# **Seabrook Station Unit 1**

### **License Amendment Request**

Update Pressure-Temperature Limits (PTL) Curves'  
Period of Applicability Based on Latest Fluence Projections

**February 23, 2022**

FIGURE 3.4-2  
REACTOR COOLANT SYSTEM HEATUP LIMITATIONS – APPLICABLE UP TO 55 EFPY

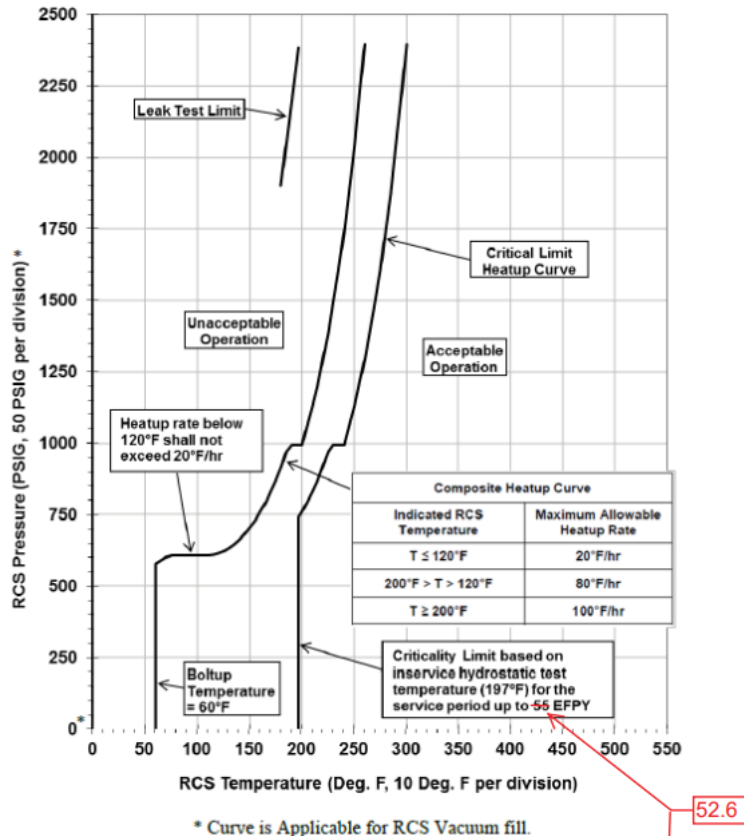
- TS 3.4.9.1, Figures 3.4-2 and 3.4-3  
TS 3.4.9.3, Figure 3.4-4
- Change Period of Applicability from 55 EFPY to 52.6 EFPY where specified
- Address Non-Conservative TS per RG 1.239.
  - Currently in Seabrook CAP
  - Seabrook was at 26.46 EFPY at EOC 20 (Spring 2020)
- No other proposed changes
- Process as normal LAR
